Subject: Crystal River Unit 3
Docket No. 50-302
Operating License No. DPR-72
Identification and Resolution of Long-Term Generic Issues
Related to the Commission of May 1979

With reference to ATTACHMENT A TO ENCLOSURE 1, LISTING OF OUTSTANDING ITEMS RELATED TO B&W SMALL BREAK ANALYSIS, of your subject letter dated August 21, 1979, attached are:

RESPONSE TO QUESTION 1B OF ATTACHMENT A TO D. F. ROSS
(NRC) LETTER DATED 8/21/79

FIGURE 5. HOT LEG FLOW

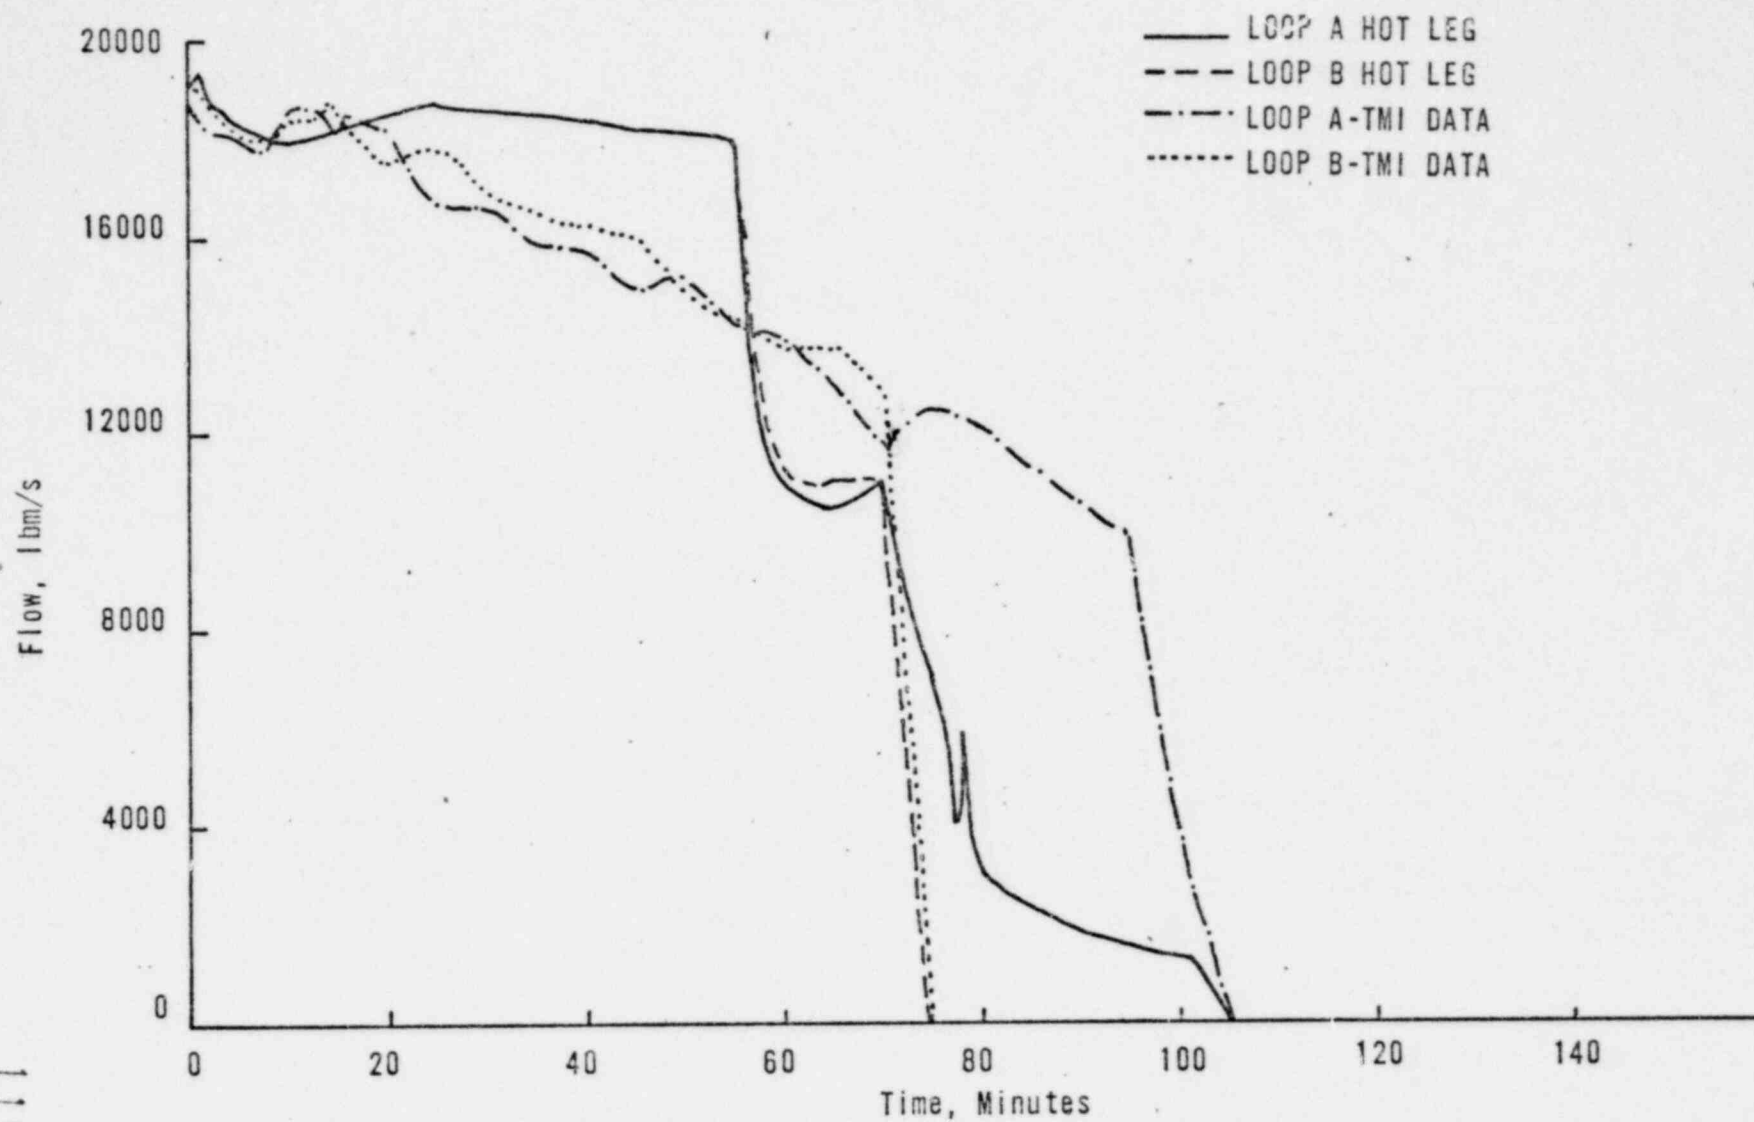
Figure 5 shows a comparison of the predicted and transient loop flows. As shown, the predicted flow rates do not match well with the actual data. This disagreement is caused by two factors. First, loop flow was measured by Gentillis tubes, which are calibrated based on single phase flow. Their actual performance during two-phase flow is unknown. Secondly, performance of the RC pumps with two-phase flow is not well understood. In performing the evaluation, a two-phase pump degradation multiplier based on the semiscale pump tests was utilized. This multiplier results in a sharp decrease in pump head once any significant voiding is calculated at the pump inlet. As shown, at 55 minutes, the loop flow sharply decreased due to this effect. Although the agreement is not excellent, the pump flow calculation does not appear to have significantly affected the simulation.

FIGURE 6 HOT TEMPERATURE

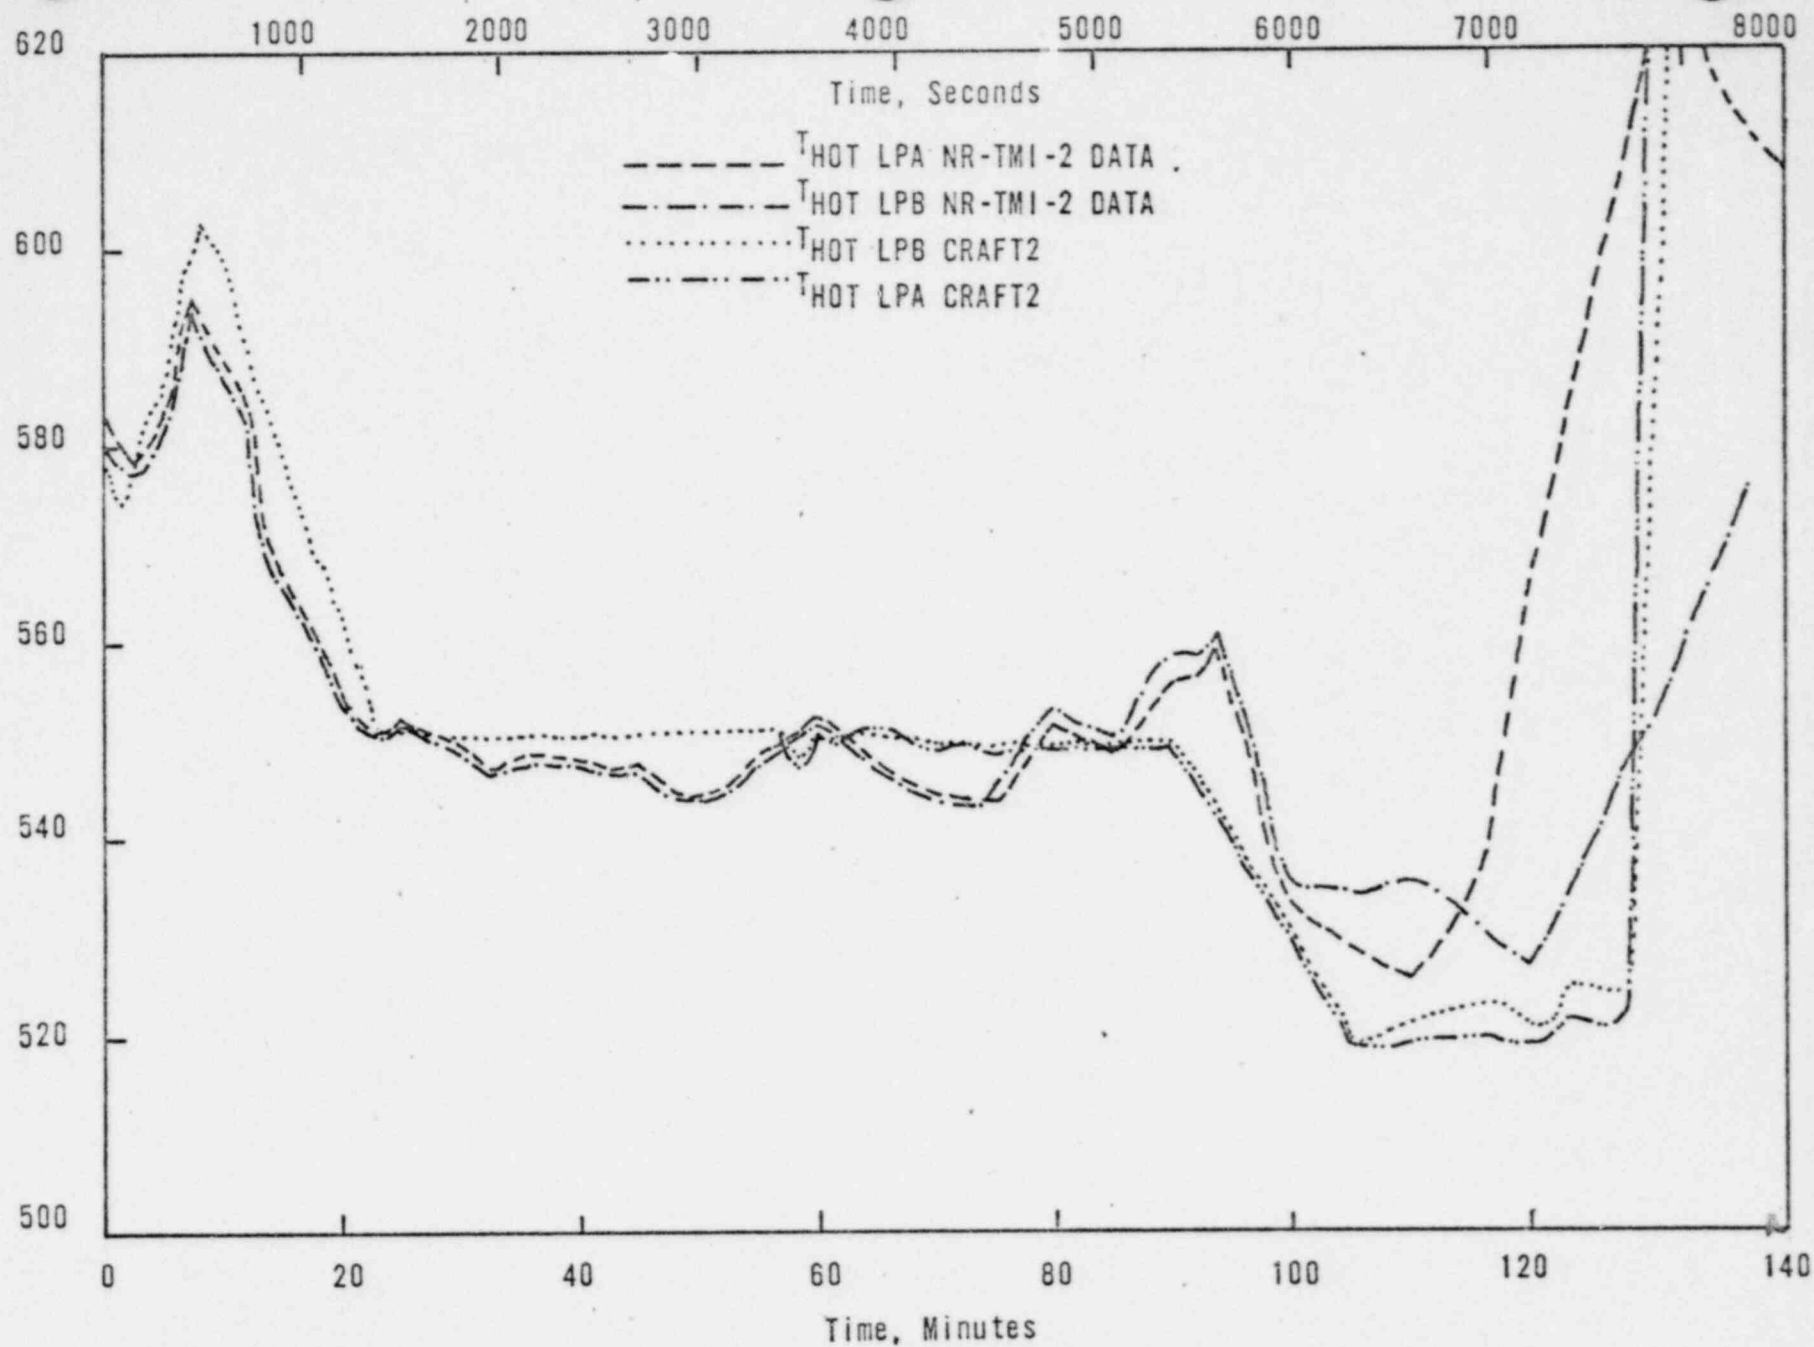
Figures 6 and 7 show a comparison of the predicted versus actual response of the hot and cold leg temperature measurements during the transient. After 5 minutes and up to the time the core started to uncover, the RCS was saturated, and the fluid temperature comparison has the same deviations previously discussed in section 3.1.

After the core starts to uncover, which occurs at approximately 110 minutes, the hot leg temperature measurement indicated superheated steam (Figure 6). However, the CRAFT2 prediction does not exhibit this behavior. This is due to the one-node representation of the core and the equilibrium assumption of the

FIGURE 8 CORE MIXTURE LEVEL

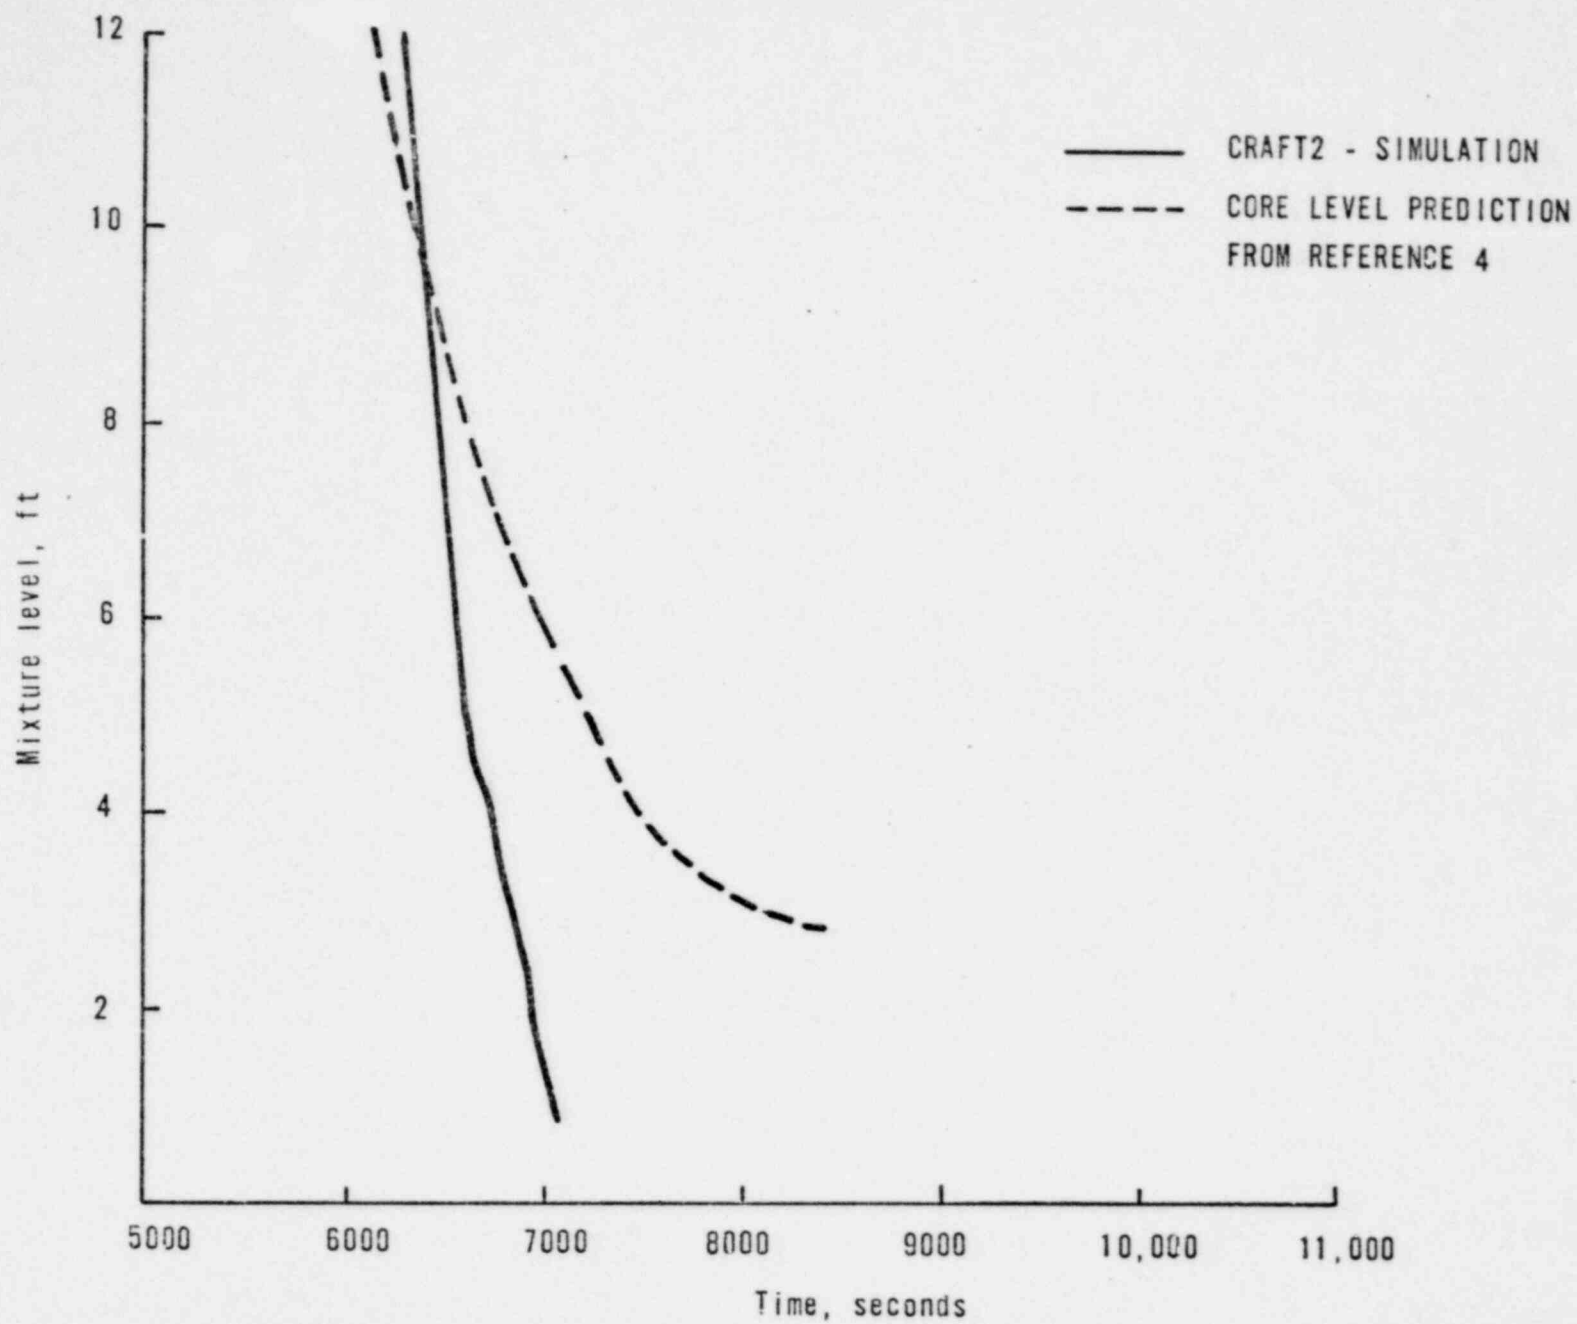
The calculated core mixture level for the transient is given in Figure 8. As shown, no core uncover was calculated while the RC pumps were operating. However, closely following the termination of the RC pump flow, the level in the core decreased. Core uncover was calculated to start occurring at 105 minutes into the transient. This compares reasonably well with the NSAC prediction of approximately 103 minutes. Thus, the calculated loss rate through the PORV and the net makeup to the RCS must be in reasonable agreement with the actual behavior during the TMI-2 incident.

As shown by Figure 8, the core was predicted to totally uncover. However, this result occurs due to the insufficient spatial detail in the core region. The simulation assumes that all core heat is removed and deposited in the fluid. This results in an overprediction of the core boil-off once the core is uncovered. A more detailed core model is necessary in order to predict how much core heat is deposited in the liquid region for subsequent boil-off of the

FIGURE 9 SYSTEM VOIDS VS. TIME USING BEST ESTIMATE HPI FLOWS

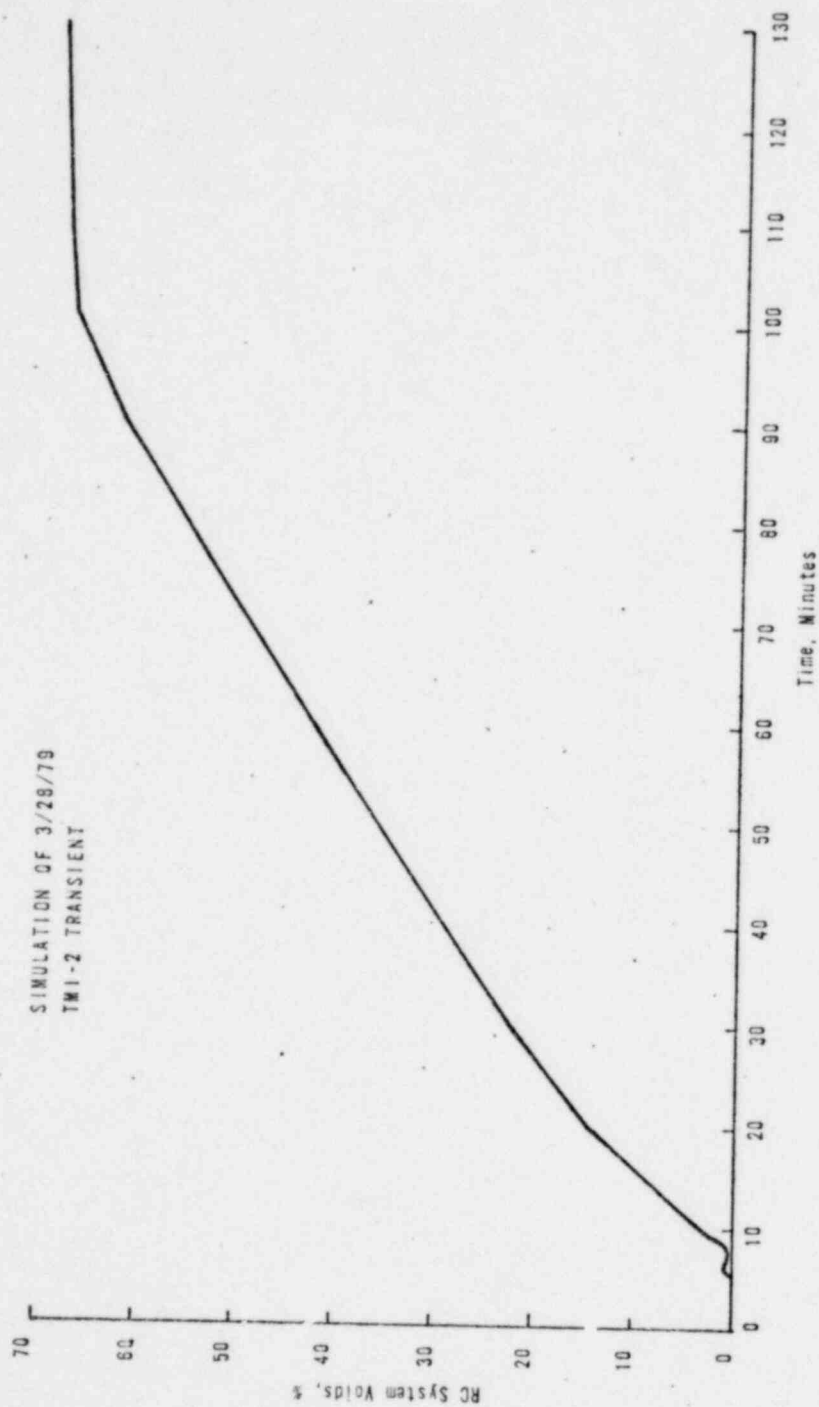
The average system void fraction evolution for the primary system, excluding the pressurizer, is shown on Figure 9. Due to the continued loss of RCS inventory through the PORV and the inadequate net makeup to the RCS, the system void fraction increases almost linearly from 10 until 101 minutes into the transient. At 101 minutes all the RC pumps have been tripped. At this time, the RCS liquid inventory is distributed as follows; the RV is filled to slightly above the top of the core; the loop seal in the B loop is full; the A loop has very little inventory. During the subsequent 30 minutes, the RV inventory is boiled-off and the steam is condensed by the A loop steam generator. Because of the lowered loop design, this inventory remains trapped within the A loop pump suction piping and the steam generator. During this period of time, the core becomes uncovered. Thus, since the process is a redistribution of water within the RCS with the only fluid loss being steam vented through the PORV, the system average void fraction does not change significantly.
